Docket	:	<u>A.25-06-017</u>
Exhibit Number	:	<u>CA-05A</u>
Commissioner	:	<u>M. Baker</u>
Admin Law Judge	:	<u>R. Haga</u>
Witness	:	<u>A. Asadi</u>

**PUBLIC ADVOCATES OFFICE
CALIFORNIA PUBLIC UTILITIES COMMISSION**

**TESTIMONY ON
PREVENTIVE MEASURES FOR WILDFIRE RISK
FOR MOUNTAIN VIEW FIRE
COST-RECOVERY APPLICATION**

Reasonableness of Operations Prior to Ignitions

Figure 4:
Liberty's De-energization decision tree for only Liberty's Topaz 1261
and Muller 1296 circuits.⁶⁸

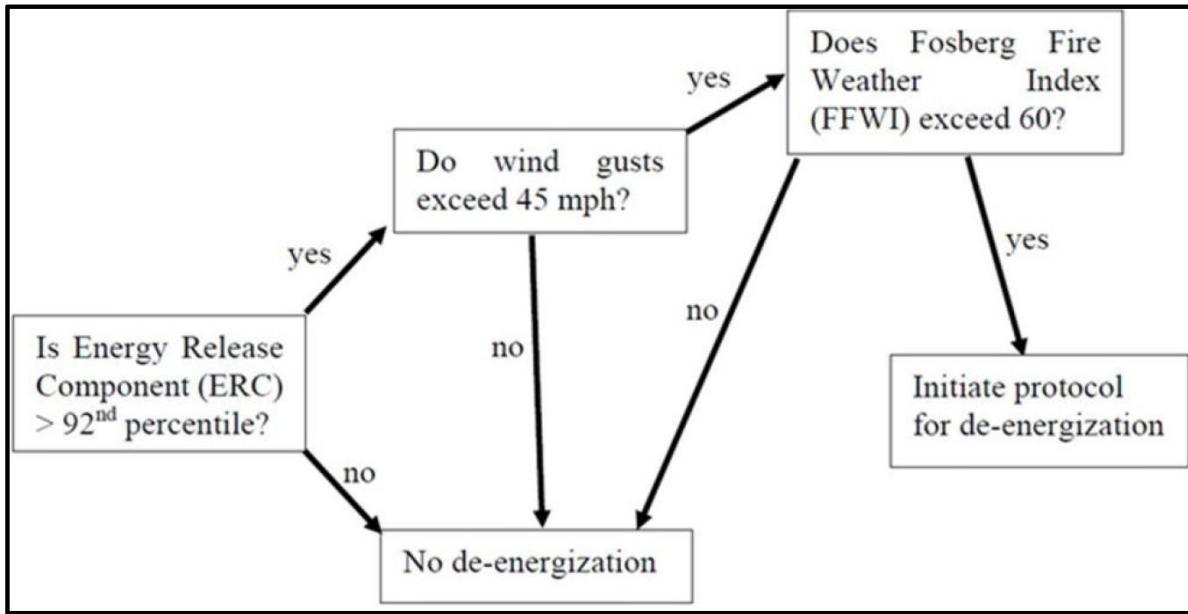
3 Liberty hired a “fire science and risk modeling consultant in 2019 to support
4 developing a more sophisticated PSPS protocol comprising a set of criteria and guidelines
5 for de-energization.”⁶⁵ Liberty’s new PSPS protocol “used a predictive tool to capture
6 three fire weather components: (a) Energy Release Component (‘ERC’); (b) wind gusts;
7 and (c) Fosberg Fire Weather Index (‘FFWI’).”⁶⁶ Figures 3 and 4 below show Liberty’s
8 de-energization decision trees. Liberty assigned a higher wind gust threshold and higher
9 FFWI threshold for the Topaz 1261 and Muller 1296 circuits (Figure 4) than the rest of
10 Liberty’s circuits (Figure 3).

9 Although Reax Engineering provided Liberty analysis to show how it determined
10 Liberty’s de-energization thresholds, it was premature of Liberty to rely on these
11 thresholds without understanding the implications of the decision tree.⁸⁰ There were
12 some issues with each decision tree level, as will be discussed further next.

1
2 **Figure 5:**
Liberty's Fosberg Fire Weather Index as calculated by its LIB-26 weather station on November 17, 2020.¹⁰²

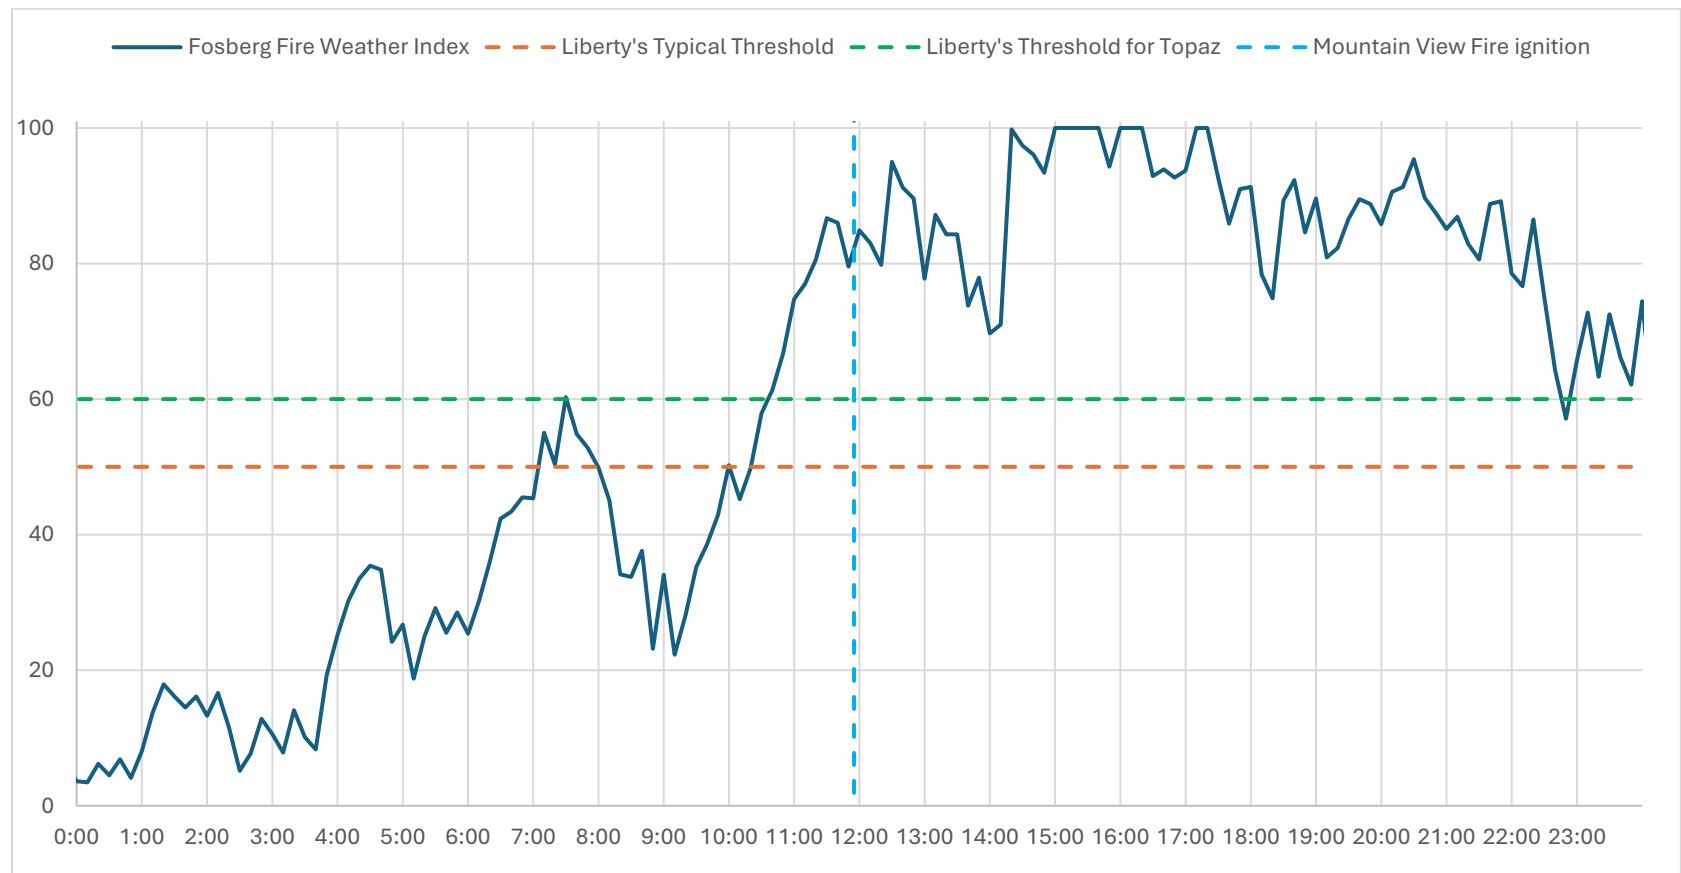
1 threshold of 60 for Topaz. Figure 5 below shows that the real-time calculation for
2 Fosberg Fire Weather Index hit Liberty's threshold for Topaz at 7:30 am and then again
3 exceeded this threshold at 10:40 am and stayed above this value through the time of the
4 Mountain View Fire ignition.

Figure 7:
Liberty's fire weather dashboard forecast for Topaz zone's FFWI at 6:00am on November 17, 2020.¹¹⁶

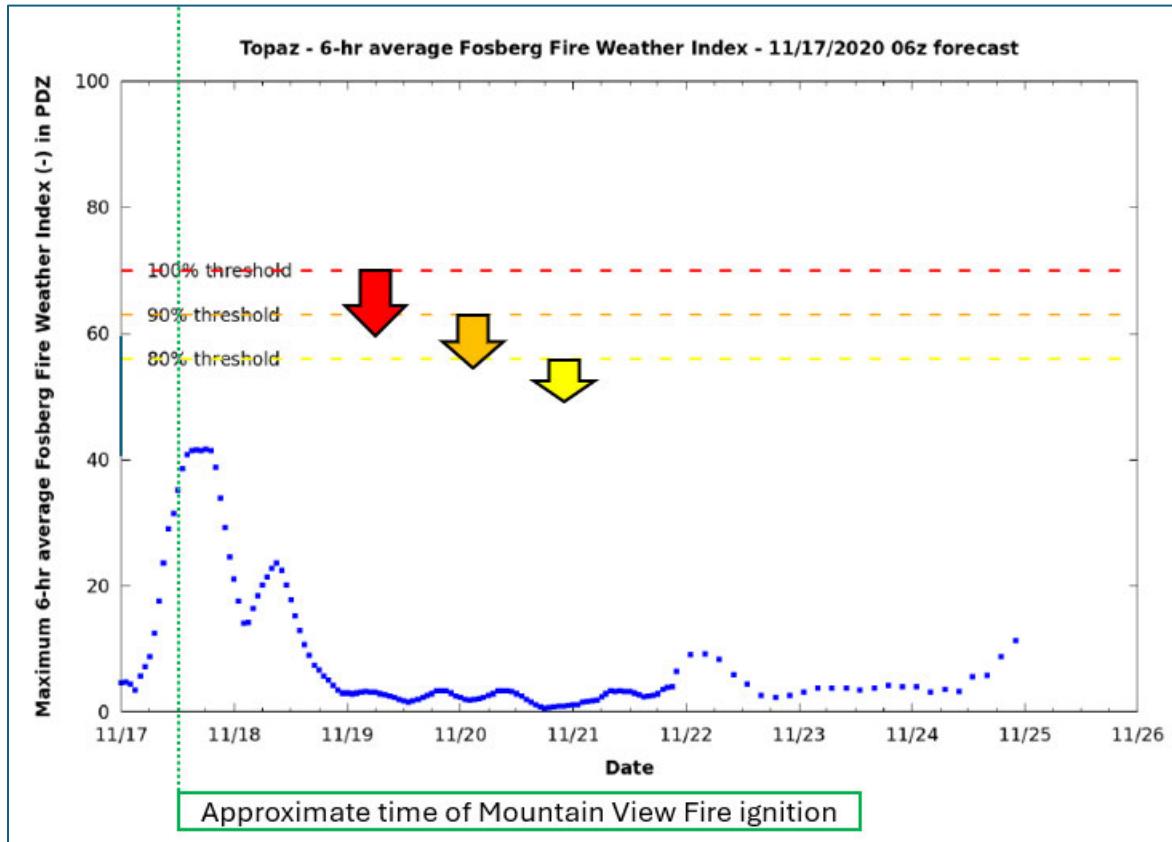
11 As can be seen in Figure 7, which shows the FFWI forecast for the Topaz zone on
12 November 17, 2020 at 6:00 am, this incorrect representation of the threshold values
13 makes interpretation of the graphs difficult. The dotted blue curve represents the
14 forecasted FFWI values while the dashed red, orange, and yellow lines are what Liberty's
15 fire weather dashboard actually displayed. The red, orange, and yellow arrows were
16 added to this image to show where the dashed lines respectively should approximately
17 have been. The dotted green line was added to this image to show when the Mountain
18 View Fire would approximately occur.

1
2 **Figure 8:**
3 **Liberty's fire weather dashboard forecast for Topaz zone's wind gust at 6:00am on**
November 17, 2020.¹¹⁷

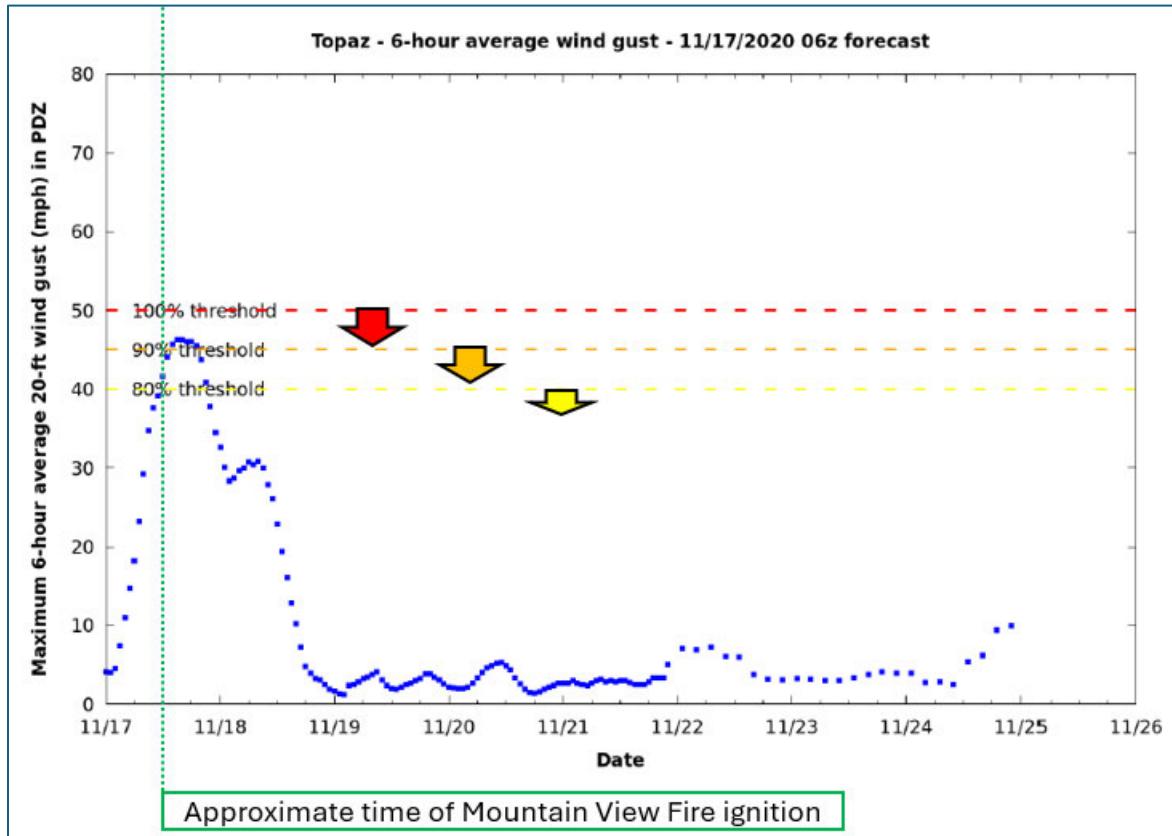
5 As can be seen in Figure 8, which shows the wind gust forecast for the Topaz zone
6 on November 17, 2020 at 6:00 am, this incorrect representation of the threshold values
7 makes interpretation of the graphs difficult. The dotted blue curve represents the
8 forecasted wind gust values while the dashed red, orange, and yellow lines are what
9 Liberty's fire weather dashboard actually displayed. The red, orange, and yellow arrows
10 were added to this image to show where the dashed lines respectively should have been.
11 The dotted green line was added to this image to show when the Mountain View Fire
12 would approximately occur.

1
2 **Figure 9:**
3 **Liberty's fire weather dashboard forecast for Portola zone's FFWI at 6:00am on**
November 17, 2020.¹²⁶

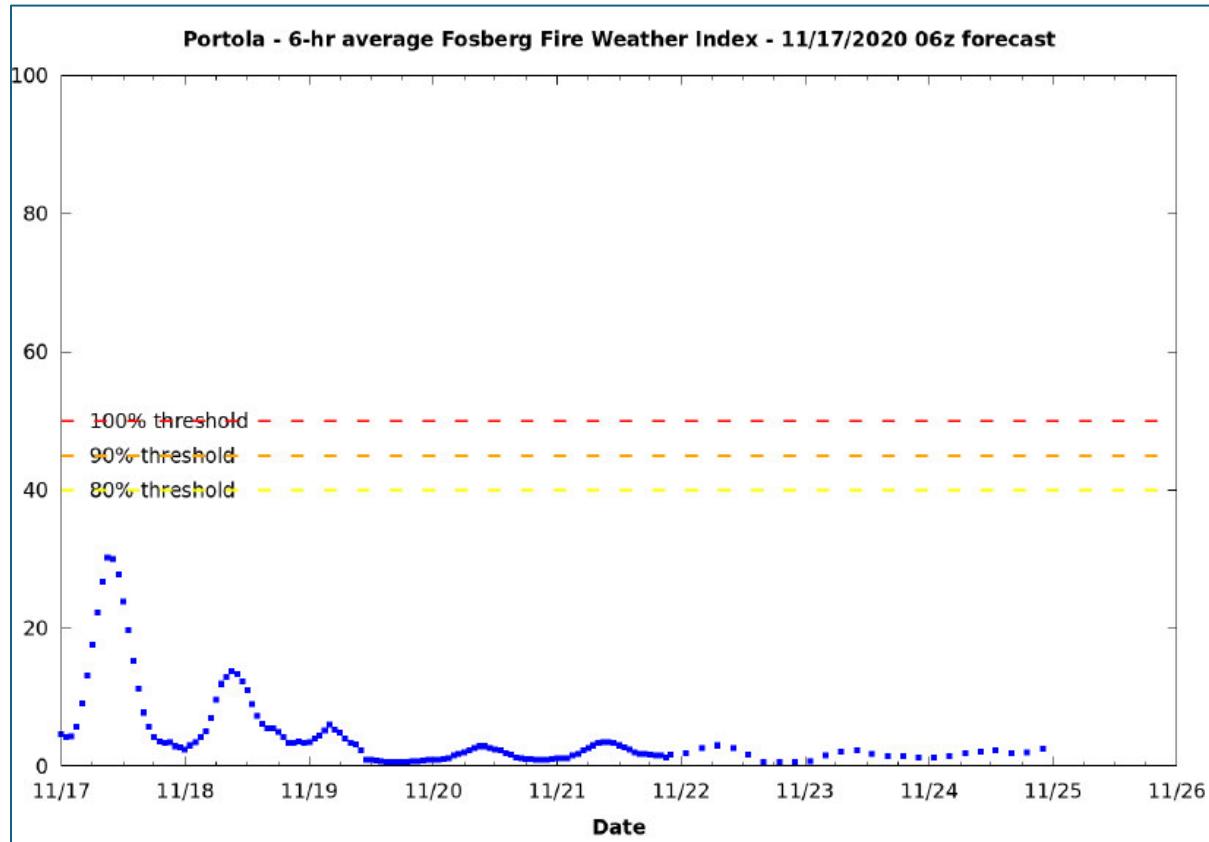
As can be seen in Figure 9, which shows the FFWI forecast for a typical zone (in this case the Portola zone) on November 17, 2020 at 6:00 am, this is clear to read. The dotted blue curve represents the forecasted wind gust values while the dashed red, orange, and yellow lines are what Liberty's fire weather dashboard displayed. These lines appear to be correctly placed.

1
2 **Figure 10:**
3 **Liberty's fire weather dashboard forecast for Portola zone's wind gust at 6:00am on**
4 **November 17, 2020.¹²⁷**

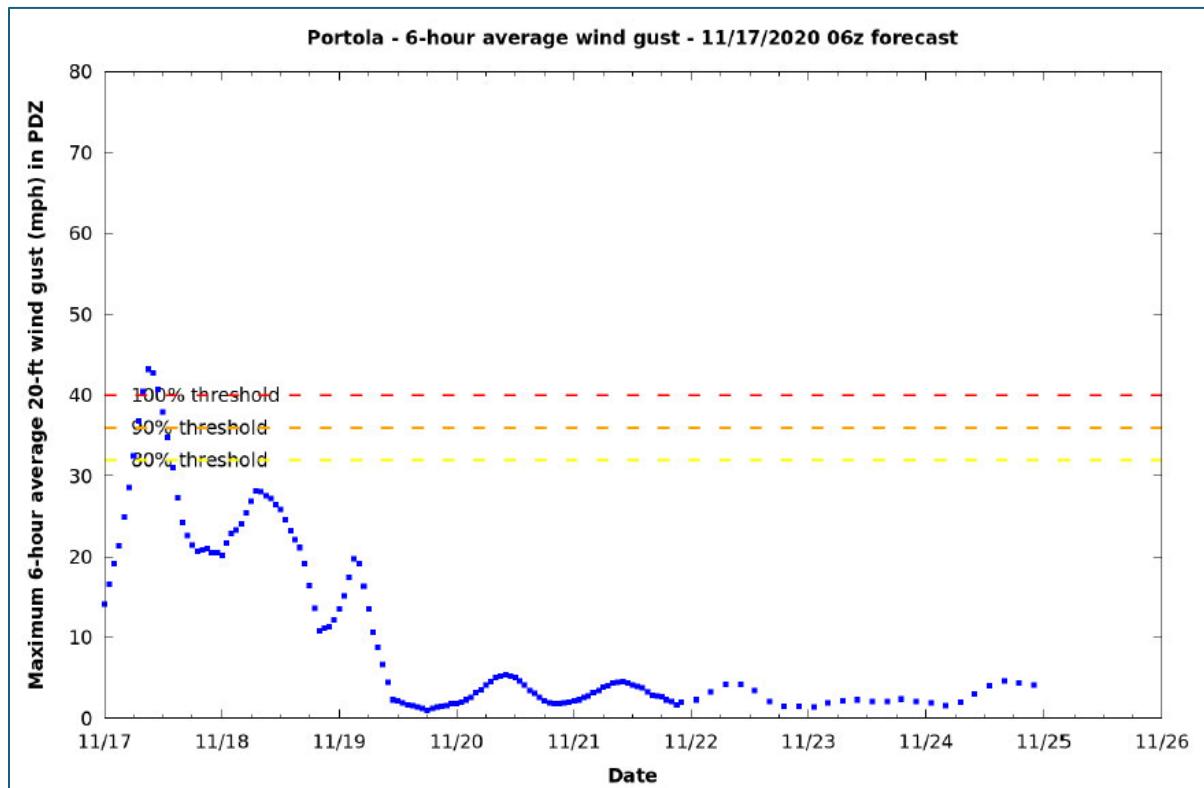
8 The dotted blue curve represents the forecasted wind gust values while the dashed red,
9 orange, and yellow lines are what Liberty's fire weather dashboard displayed. These
10 lines appear to be correctly placed.

1
2 **Figure 11:**
3 **Topaz zone forecast from Liberty's fire weather dashboard made at 6:00 am on**
3 **November 17, 2020.**¹⁶⁵

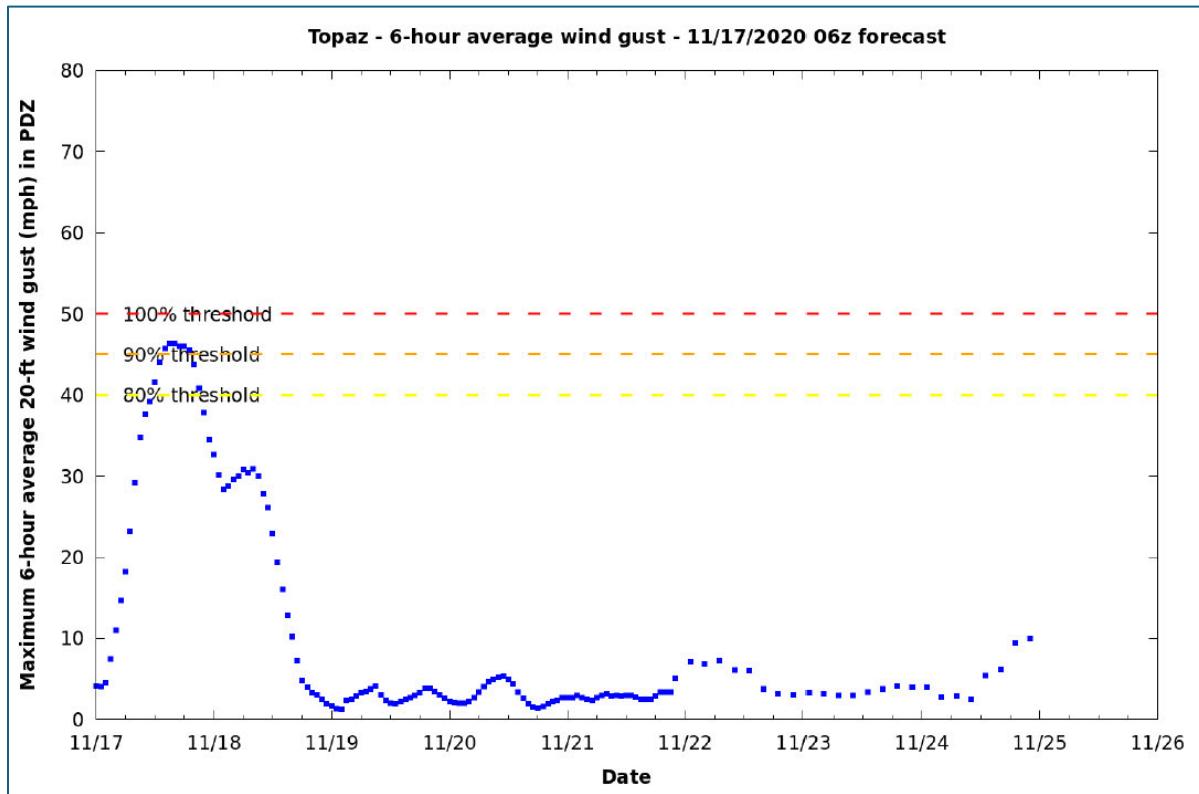
6 On the morning of November 17, 2020, at 9:48am, Liberty’s Topaz 1261 circuit
7 experienced a suspected wire slapping event,¹⁶⁰ which caused an outage¹⁶¹ that occurred
8 at a wind gust speed of approximately 45.5 mph.¹⁶² Notably, this wind gust speed
9 approached Liberty’s wind gust forecast (approximately 45 mph, which was incorrectly
10 shown as below the 100% threshold)¹⁶³ (see Figure 11 below) and surpassed Liberty’s
11 PSPS criteria predefined wind gust threshold (45 mph).¹⁶⁴ This should have alarmed
12 anyone monitoring the system. Indeed, this warranted a risk assessment.
